**BEFORE THE PUBLIC UTILITIES COMMISSION OF THE  
STATE OF CALIFORNIA**

Rulemaking 12-03-014  
(Filed March 22, 2012)

**COMMENTS OF THE CALIFORNIA INDEPENDENT  
SYSTEM OPERATOR CORPORATION ON STANDARDIZED  
PLANNING ASSUMPTIONS AND STUDY SCENARIOS**

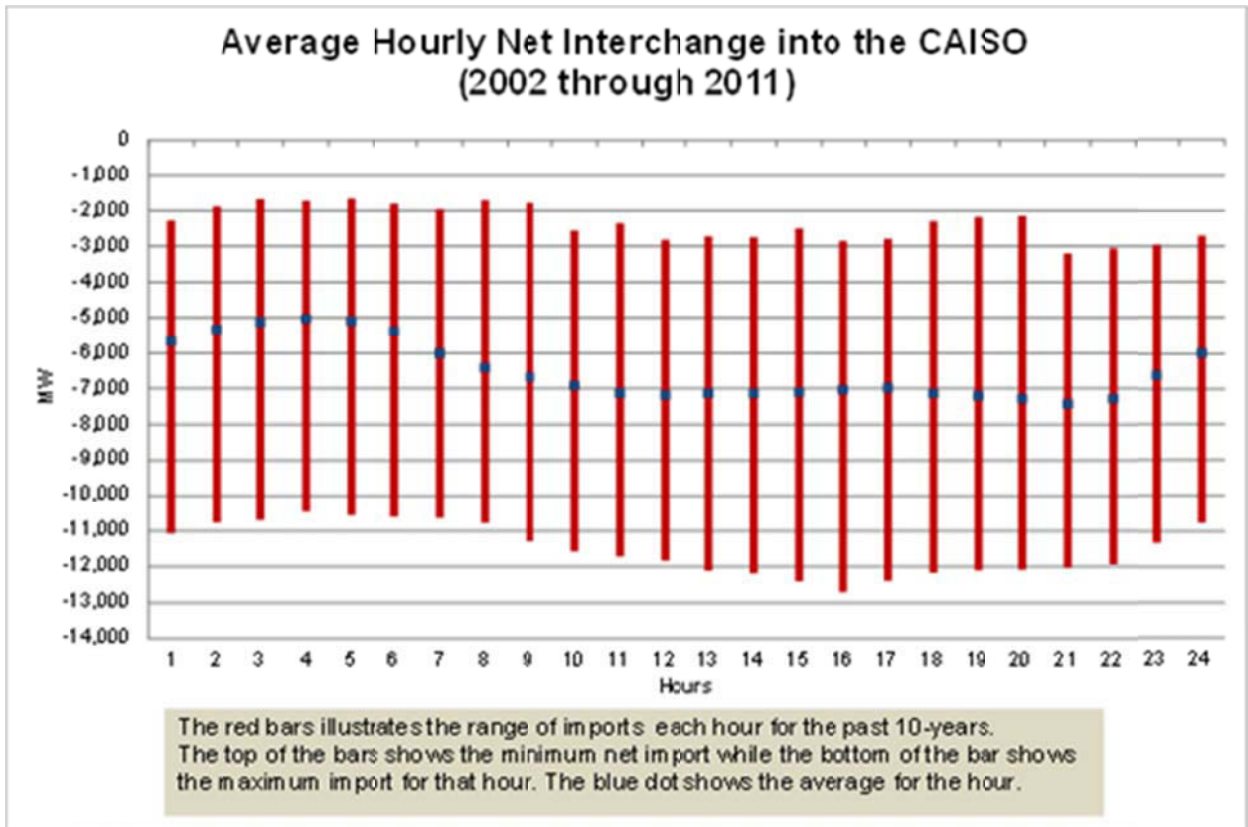
The ISO recommends that the expected import assumed for the purposes of scenarios be established based on the maximum historical actual simultaneous observed imports into CAISO of 12,400MW. The ISO has not observed actual simultaneous net imports in excess of 12,400MW in the last 10 years (see figure below). For the purposes of the

flexibility need assessment, the ISO intends to calculate, similar to what is has in the past, seasonal CA Import limits that account for SCIT limitations.
